Document Description: CSB-SPOT LXI_LED LCD INSTALL	Document Number: 80021534 Version: B

Customer Service Bulletin

Product:	SPOT LXi 4500 Vital Signs	Date:	2016-06-07
Subject:	720480 / DISPLAY,LCD,320X240,LED,MONO,3.3V,5.7" Installation		
HW Version(s) Affected:	SPOT LXi 4500 / All models	SW Version(s) Affected:	N/A
Serial Numbers Affected:	N/A	Lot or Date Code Affected:	N/A
Classification:	As Needed		
Distribution:	<input checked="" type="checkbox"/> Customer Care <input type="checkbox"/> Product Service <input type="checkbox"/> Field Service <input checked="" type="checkbox"/> ASPs <input checked="" type="checkbox"/> Distributors <input checked="" type="checkbox"/> Customers <input type="checkbox"/> Company Confidential		
Training Required:	<input type="checkbox"/> Yes <input checked="" type="checkbox"/> No

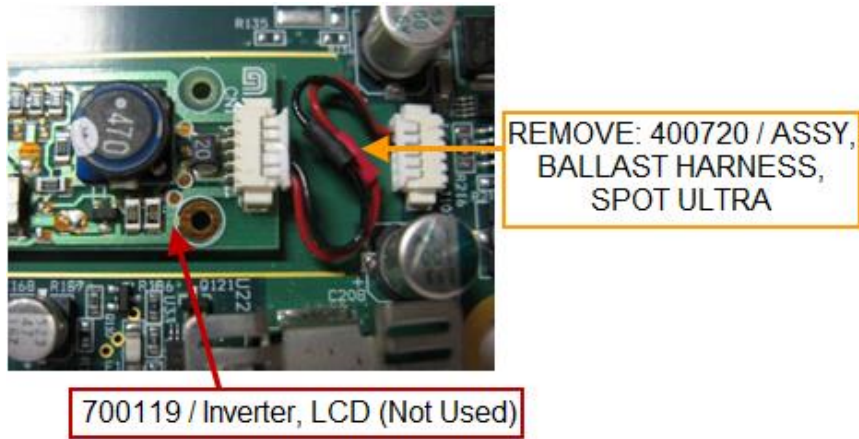
Route the LED Power Cable around the mainboard (as shown):

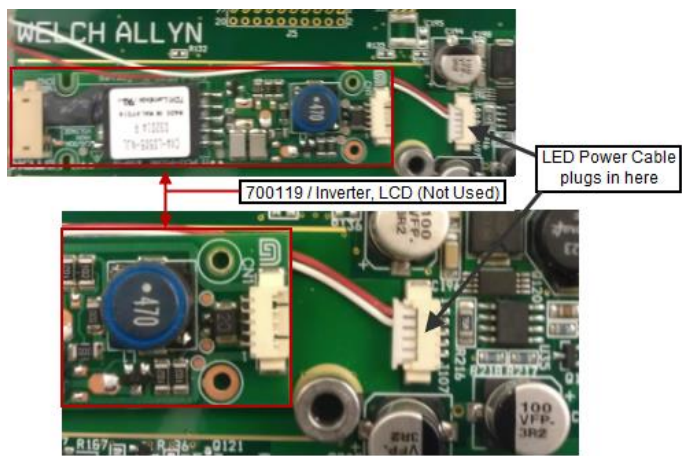
When replacing a CCFL display (703354) with an LED LCD (720480), remove the Ballast Harness assembly (p/n: 400720) from connector J107 and from the inverter board.

By-pass the inverter board with the LED Power Cable and plug it directly into connector J107 (as shown).

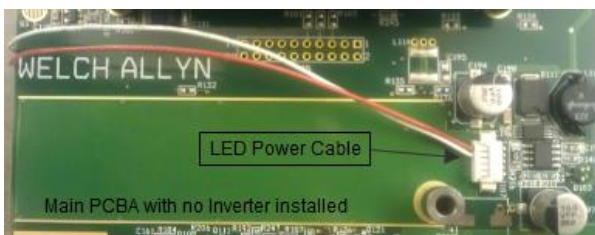
When replacing the LCD in a device that was manufactured after June 2014, there will be no inverter board installed. The LED Power Cable will plug directly into connector J107 (as shown).
